Butterfield Park

Butterfield Park is a very large neighborhood park that provides a playground, picnic areas, ballfields and a building for preschool program. The main issues at this park are not having proper accessible parking spaces, slopes, abrupt transitions, no the correct number of accessible picnic tables or on the correct surface, not having companion seating at benches and bleachers, protruding branches, restroom grab bars not properly mounted and various restroom elements out of reach ranges. . **Please Note:** When a **UD** is indicated, this is a Universal Design (**UD**) recommendation to enhance accessibility. The **UD** recommendation is not required to meet the minimum accessibility standards but it would be encouraged.

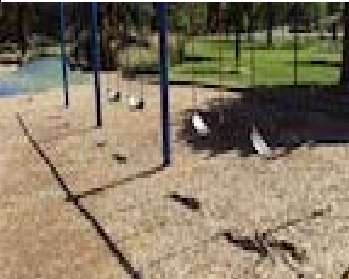
| Photo | Barrier | ADAAG/IAC | Solution | Priority | By Whom | Projected Cost | Projected Date | Action Taken |
|---|---|-------------|---|----------|---------|----------------|----------------|--------------|
|  | The north parking lot accessible parking space has a running slope too steep at between 3.2% to 7.0%. | ADAAG 502.4 | Regrade the parking space to be no steeper than 2% in all directions. | | | \$900 | 2026 | |

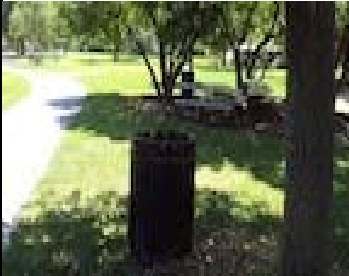
| Photo | Barrier | ADAAG/IAC | Solution | Priority | By Whom | Projected Cost | Projected Date | Action Taken |
|---|--|----------------|---|----------|----------------------|----------------|----------------|---|
|  | The adult/older child swings have a slope too steep at 8.6% to 13.1% | ADAAG 1008.4.4 | Provide a regular maintenance to the play surface to provide a seat less than 24" off the ground and a slope under the swings no greater than 2%. Consider a mat under the swing to prevent kick-out of surface material. An accessible swing with a seat would be recommended at some point. | | Hacienda Landscaping | \$100 | 2016 | Playground and pavement surfaces renovated to meet ADA guidelines, 11/2016 \$600,000 |

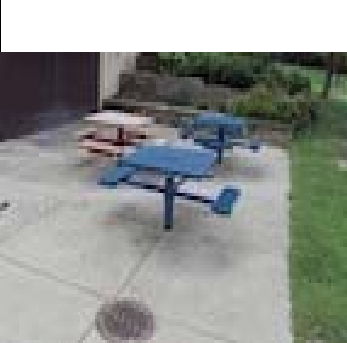
| Photo | Barrier | ADAAG/IAC | Solution | Priority | By Whom | Projected Cost | Projected Date | Action Taken |
|--|--|--|--|----------|---------------------|----------------|----------------|---|
|  | The walkway behind the tennis courts has a cross slope too steep at 2.6% to 8.7% for 110'. | ADAAG 403.3 | Remove and regrade section to provide a cross slope no greater than 2%. | | Elanar Construction | \$3,625 | 2016 | Park renovated including paths to meet ADA requirements, 11/2016 |
